CITY OF SHEBOYGAN APPLICATION FOR CONDITIONAL USE PERMIT Requirements Per Section 15.905

Narrative for Conditional Use Permit (CUP) Walmart Store 1276 (Sheboygan) Project No. 21165 3711 S Taylor Dr. Sheboygan, WI 53081

Good morning. On behalf of Walmart Stores Inc., LK Architecture, as an authorized agent, present for your consideration, a Conditional Use Permit (CUP) Application for Walmart Store 1276 located at 3711 S Taylor Dr. Sheboygan, WI.

SHEET: SD1

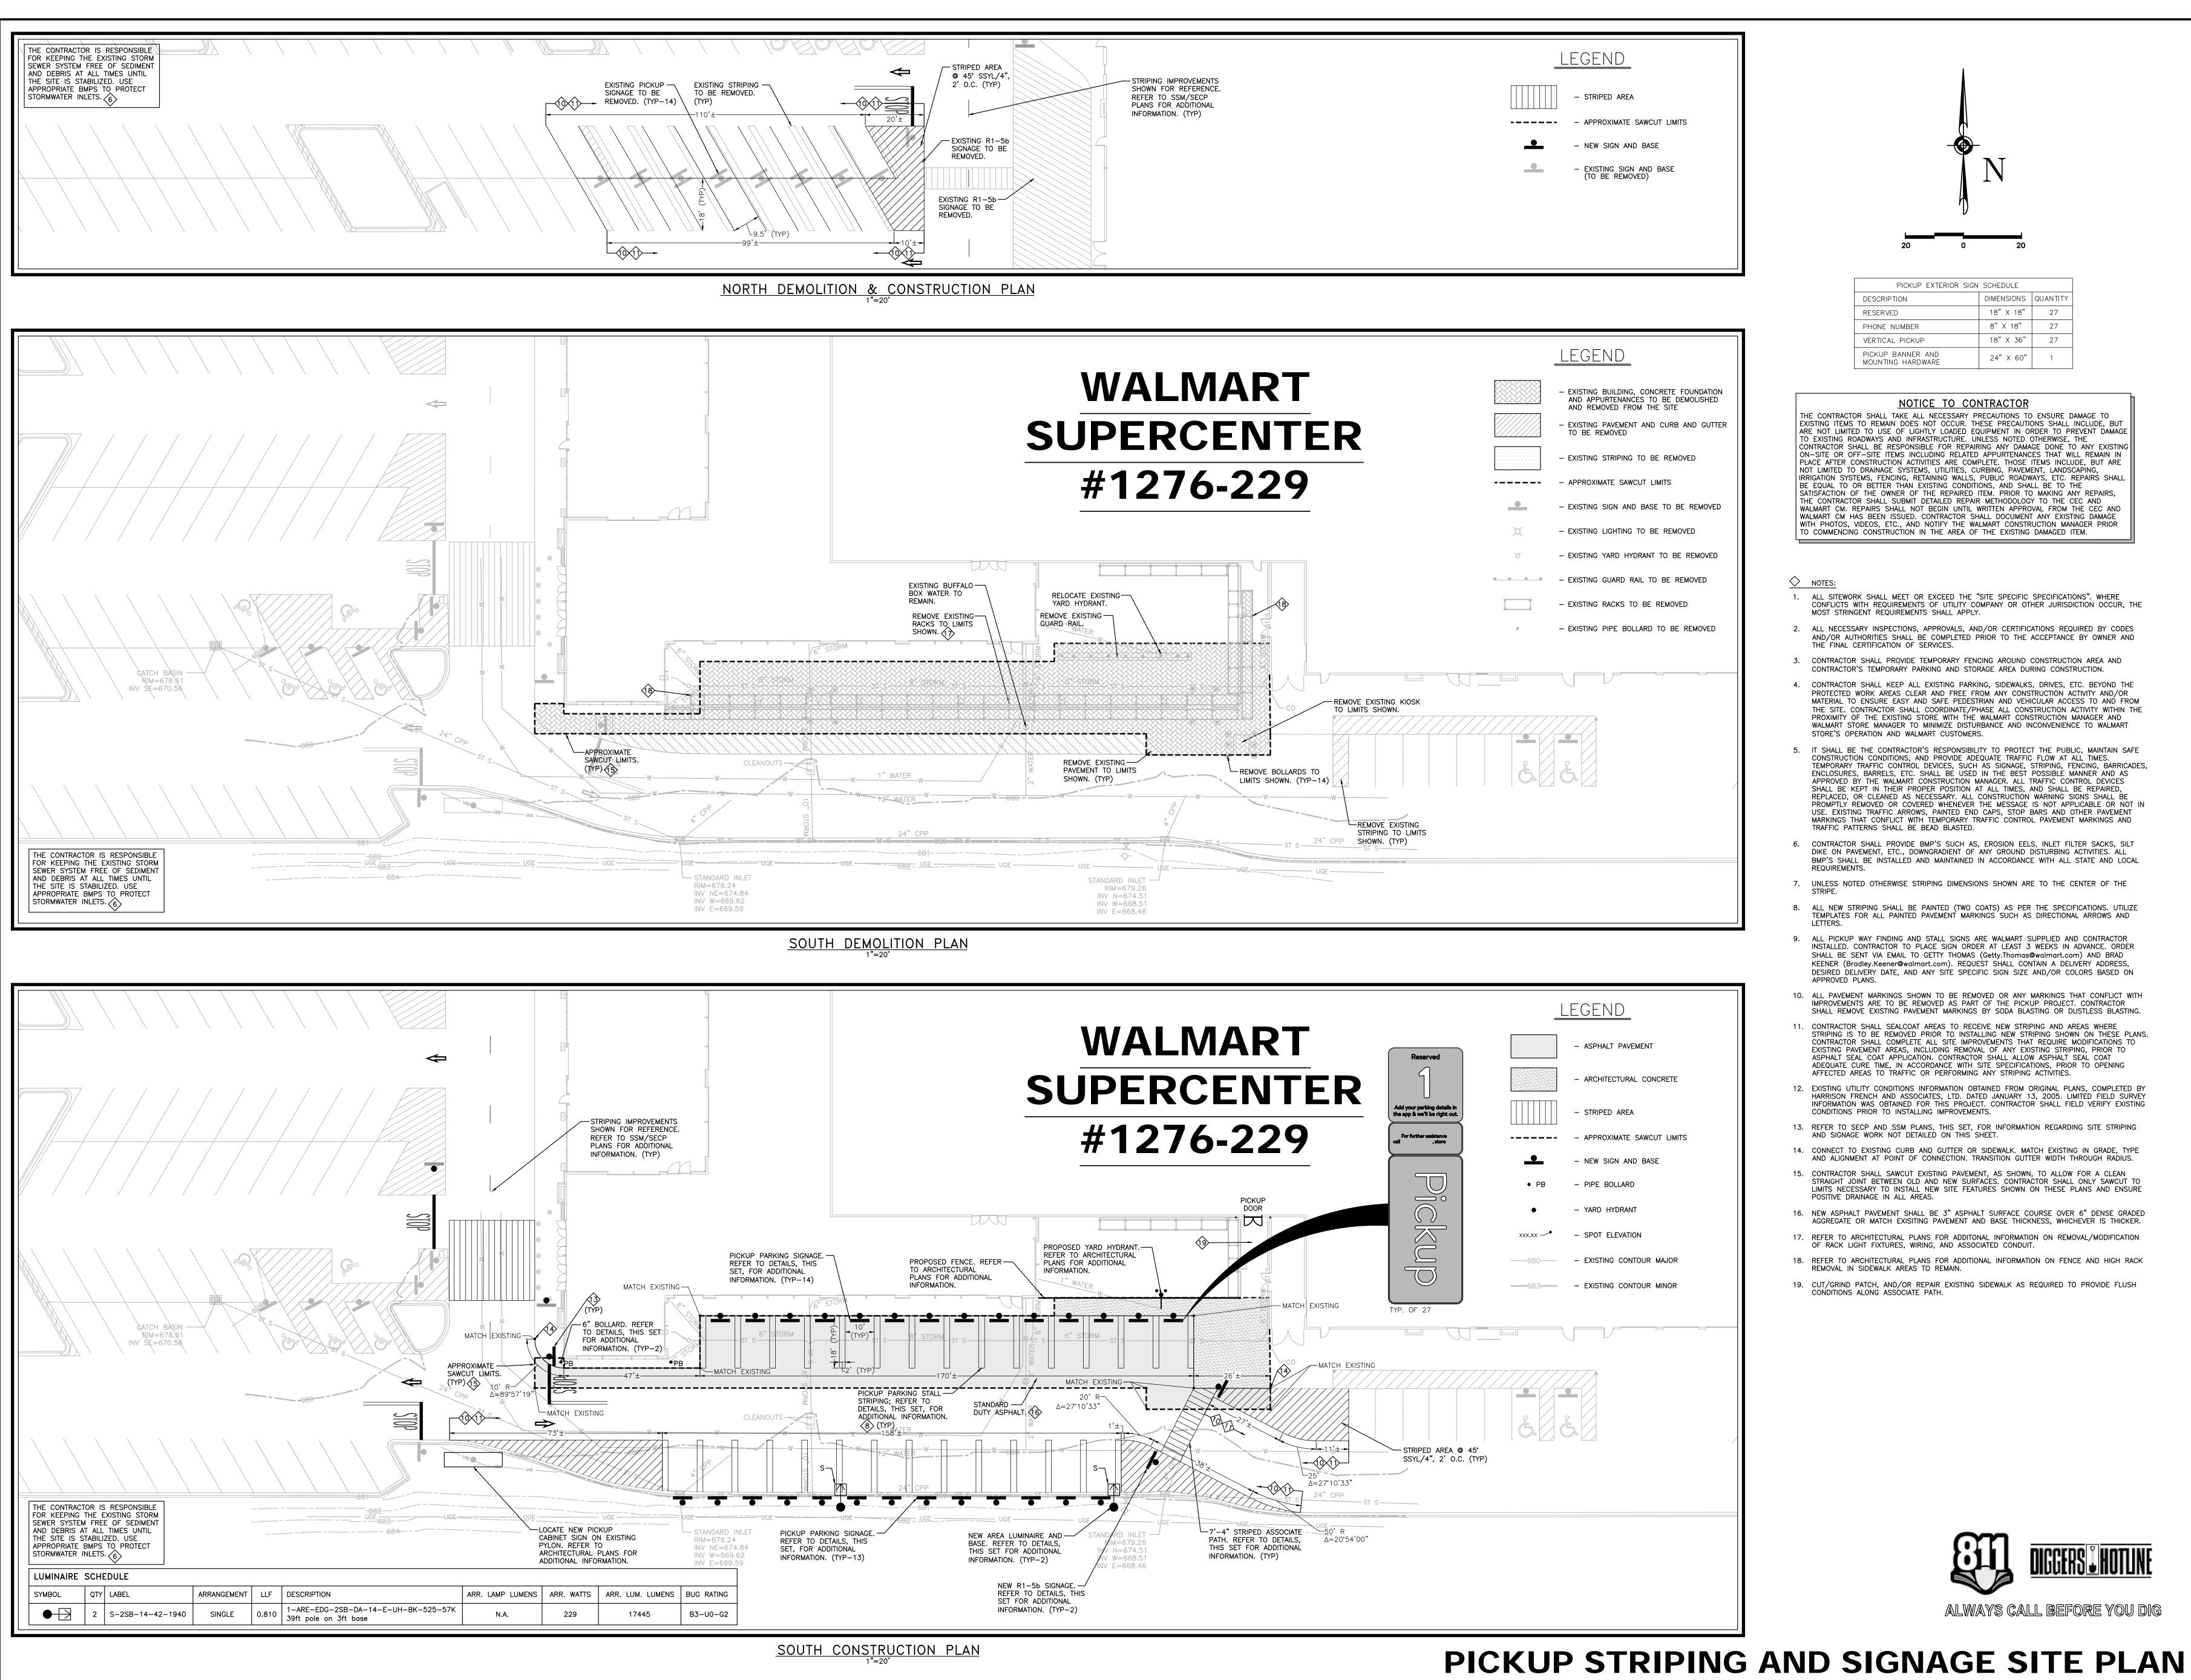
• You will have to provide an accurate site plan/survey showing that all proposed directional signage is on Walmart's private property (not sure about some at the north entrance adjacent to the Qdoba private property).

• It seems like many of the proposed directional signs are not pointing the correct directions so you will need to update the drawing accordingly.

• Looks like you are adding additional paved surface. You will need to provide the exact paving setback dimension to the property line.

Based on Sheboygan County GIS map, Walmart owns the entire drive up to the ROW of Greenwing Drive. Please reference exhibit (SD1 - Pickup Striping and Signage Plan) for signage locations.

We have confirmed the directional signage provided on the attached pdf is correct.

Additional pavement is not being added. The existing concrete is being removed and replaced with asphalt so the same amount of impervious area will be maintained. The parking lot setback from the property line will not be adjusted. Please reference exhibit (SD1 Pickup Striping and Signage Plan – South Construction Plan) for extents of new parking asphalt.
